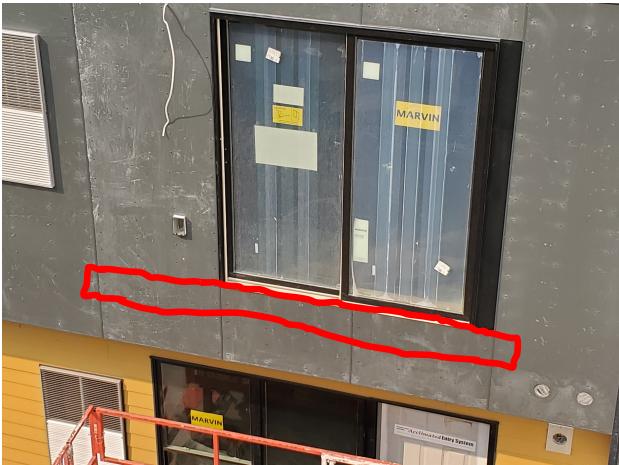
- Inspector might flag this. Codewise, this dimension has to be at least 7'-6".

- Concerned that if the ledger of the balcony is lagged tightly against the fiber cement, that the fiber cement will crack. Recommend providing a detail like 5D/A501 to assure horizontal loads from the balcony bypass the fiber cement and rigid insulation.

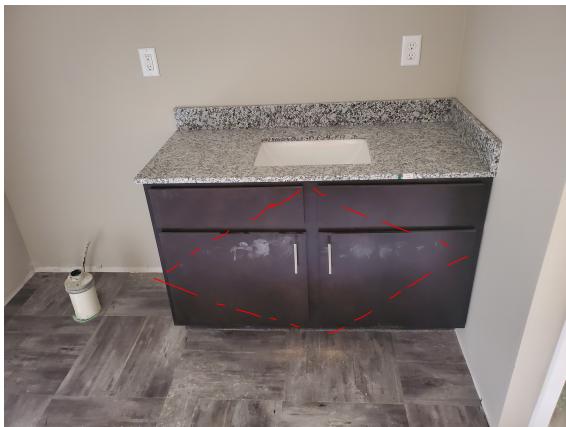
Recommend centering the light fixture on the vanity and mirror. Occurs in multiple rooms.

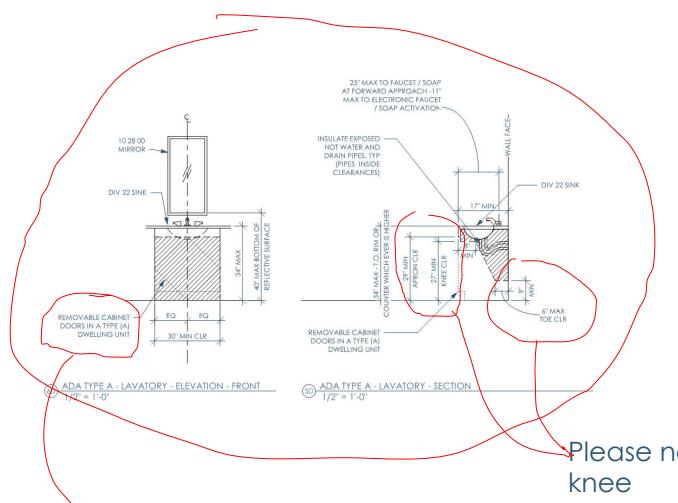
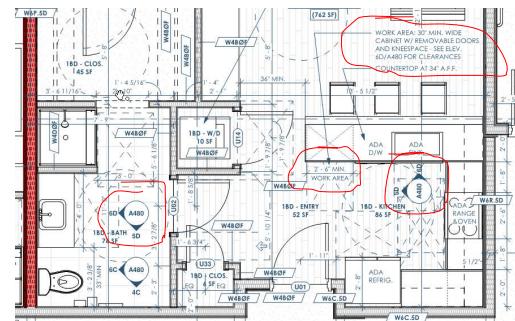
- In Room 208 (a Type A unit), the cabinets below both the kitchen sink and vanity sink need to be removeable per detail 6D and 5D/A480
- The kitchen in room 208 needs a work area with a min. clearances as outlined in 6D and 5D/A480

Please note  
knee  
clearances

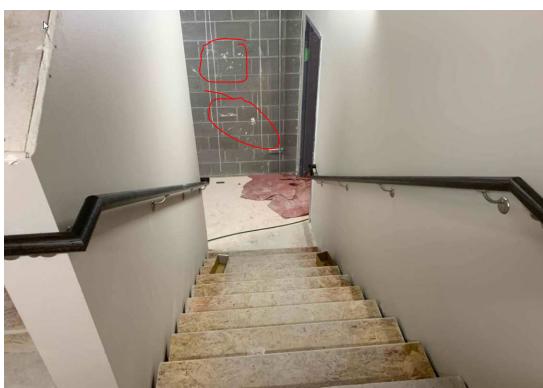
- Clean all paint/drywall from exposed CMU at all stairs and elevator
